STAFF REPORT
(Final Plat)

CASE NUMBER: S/D 95-86 TOWNE PARC 6TH ADDITION

VICINITY MAP:

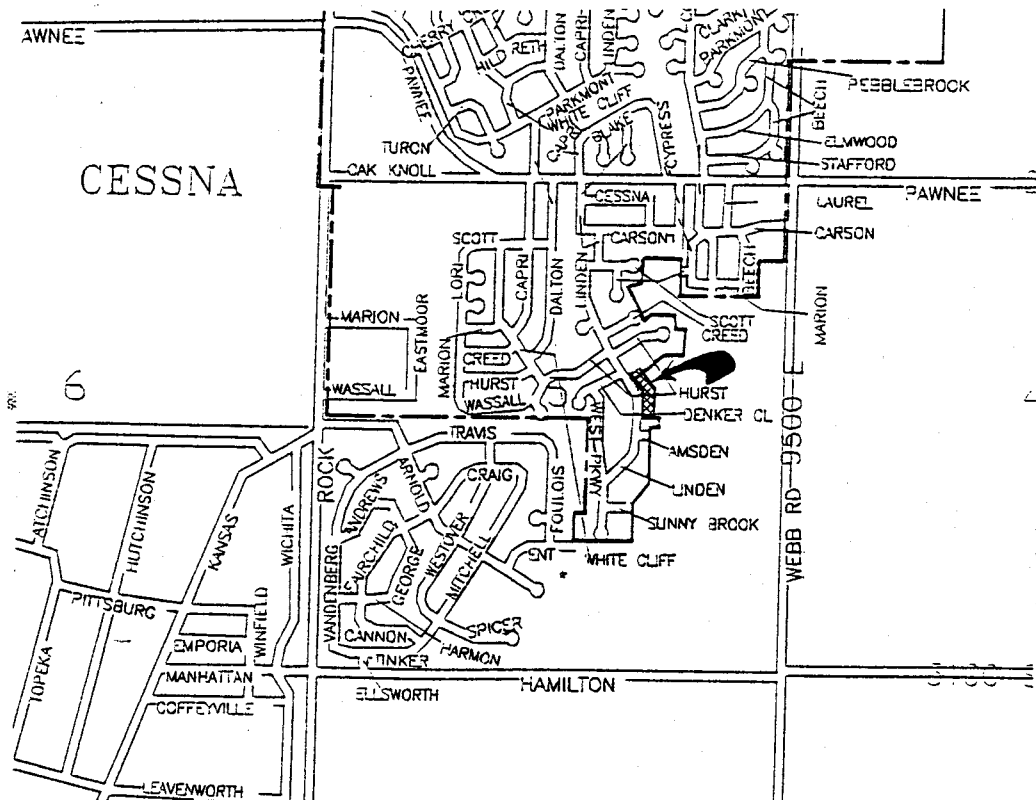
- E. As indicated by the sketch plat, an off-site utility easement is being granted by separate instrument. Such easement should be submitted to Planning for processing (acceptance and recording) with the final plat tracing.
